Subject: Zion Nuclear Power Station, Units 1 and 2
 Revisions to Second Interval Inservice
 Testing and Inspection Program
NRC Docket Nos. 50-295 and 50-304

The purpose of this letter is to revise two previously submitted relief requests, and to forward two new relief requests for your review and approval. Attachment 1 contains the two relief requests that have been revised. The first of these relief requests is IWB Relief #3, which requests relief from the requirement to perform a 100% inspection of the weld between the pressurizer nozzle and the pressurizer itself. The second of these revisions to previous relief requests is valve Relief #24, which requests relief from the requirement to perform a full stroke of the Reactor Coolant Pump seal injection manual valves on a quarterly basis. An explanation and justification of the revised relief requests are provided in Attachment 1, in addition to the updated corresponding pages of the ISI document.

NEW RELIEF REQUESTS

ZION FIGURE B13

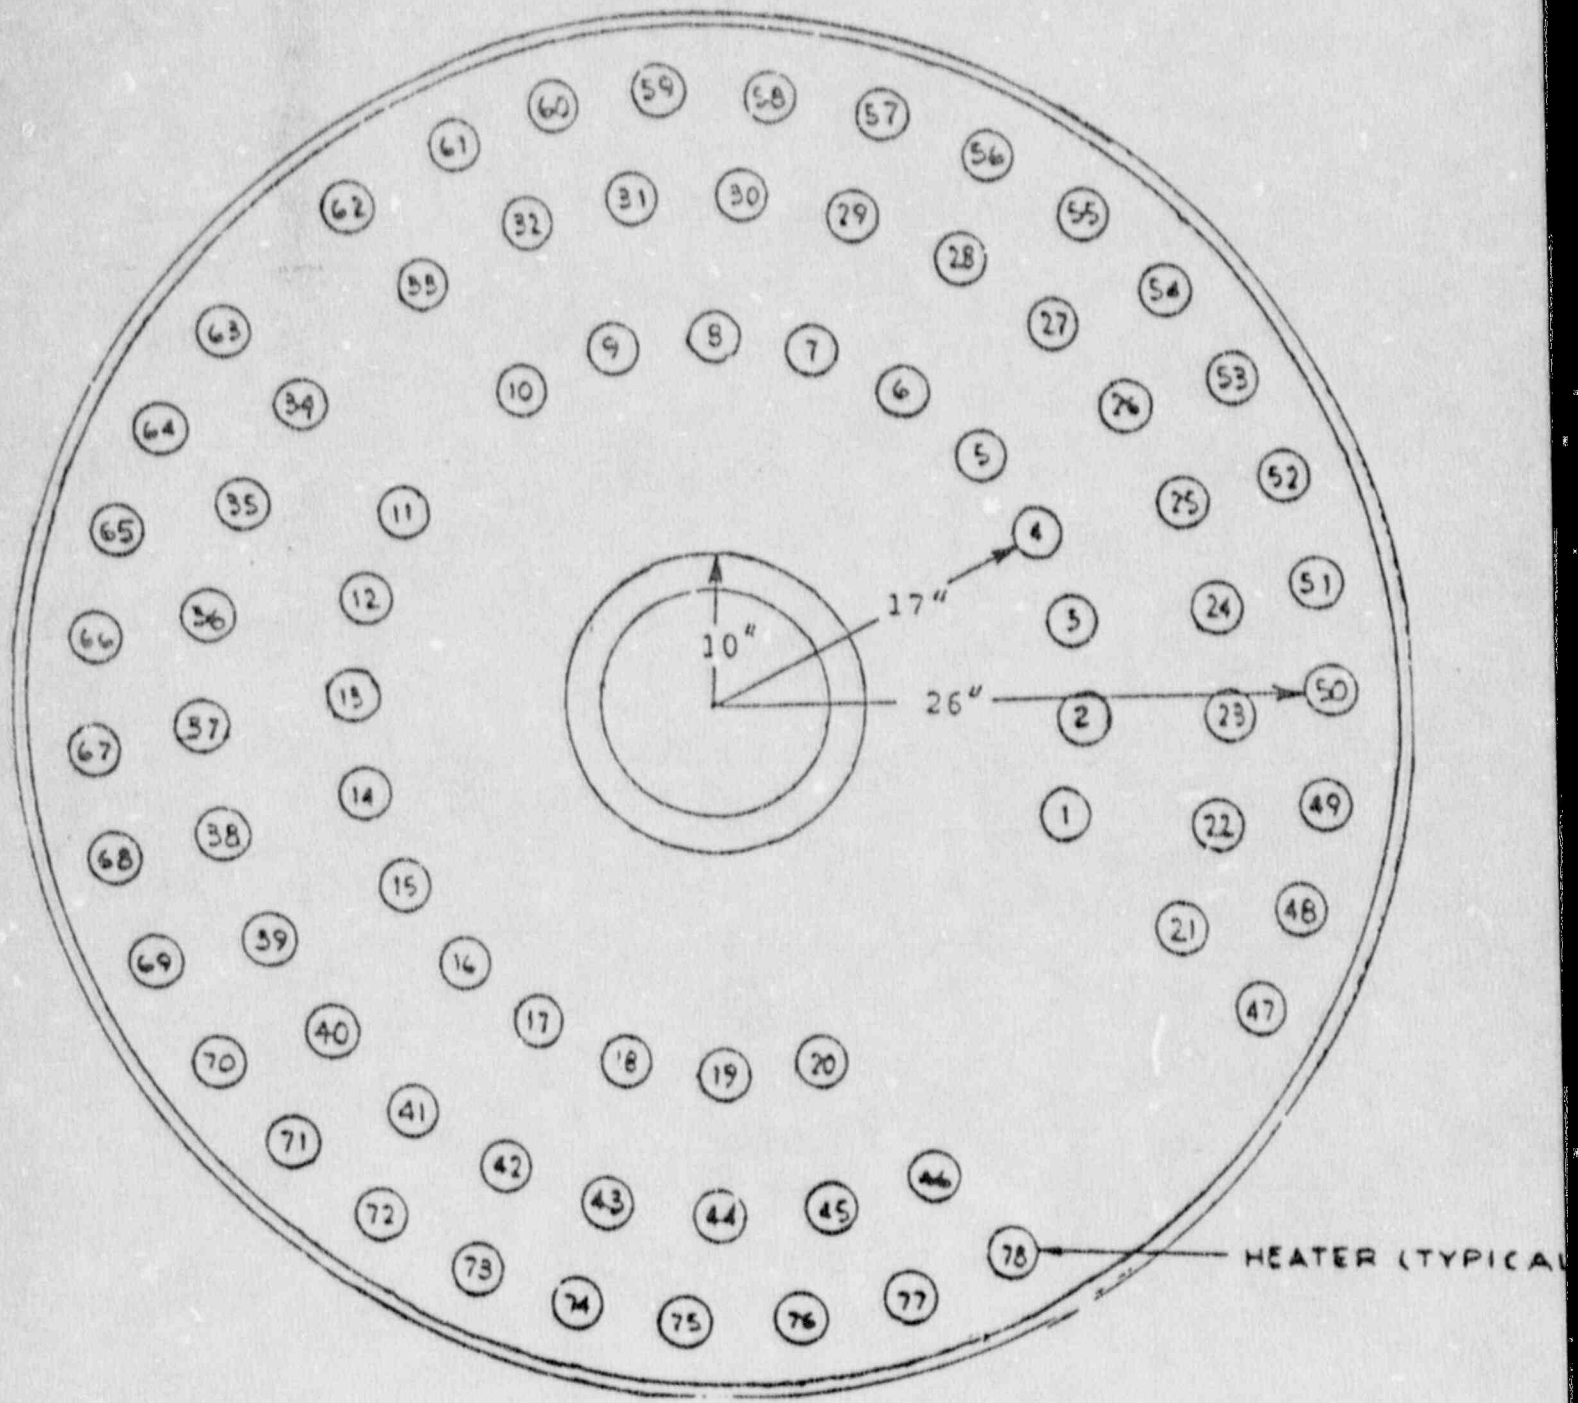
In order to perform surface and volumetric examinations, direct contact with the inspection surface is required. The bottom of the pressurizer vessel head is covered with stainless steel mirror type insulation that was not designed or originally installed to be removed for inspection purposes. This insulation is integrally configured into one piece. In order to expose the examination area, the insulation which covers the entire pressurizer vessel lower head must be removed. The insulation removal would first require disconnection and removal of all 78 pressurizer immersion heater electrical cables, (reference Zion Figures B12 and B13). The immersion heater connectors are a very delicate system which were not designed for cable removal and reinstallation. Since the component materials and configurations make it fragile and difficult to remove, permanent damage would result if there was any attempt to disconnect the cables from the heaters. This would require additional man hours to repair the damage. Furthermore, even if all the cables were disconnected, the 78 convection stops that are riveted to the insulation would individually be required to be cut and removed so that the insulation could be removed over the pressurizer heaters (reference Zion Figure B14).

Even if all the disconnections and insulation removal were made, the pressurizer surge nozzle and neighboring geometries restrict the inspectable amount of required Code weld volume to a very small percentage. No examinations can be performed from the nozzle side of the weld due to the nozzle geometry (ref. Zion Figure B15). Additionally, examinations are restricted from the shell side of the weld due to the configuration and locations of the pressurizer heater rod locations (ref. Zion Figure B13). With this situation present, any data that could be obtained would represent only a very small portion of the total weld volume. The work exposure is extremely high for the amount of information which could be gained from this examination.

Zion Station therefore requests relief from conducting volumetric examinations of the Unit 2 pressurizer surge nozzle to vessel weld. As an alternative, visual examinations shall be performed at normal operating pressure after each refueling outage, as well as, during the ten year hydrostatic pressure test. Additionally, volumetric and surface inspection data obtained this interval from the other pressurizer nozzle to vessel welds and the surge nozzle to pipe weld, (the next weld immediately downstream of the surge nozzle to vessel weld), will be utilized as indicators for general conditions of the welds and surrounding material including the pressurizer surge nozzle to vessel weld. Zion Station believes that the proposed alternative examinations will provide the necessary assurance of the structural reliability and integrity of the Unit 2 pressurizer surge nozzle to vessel weld.
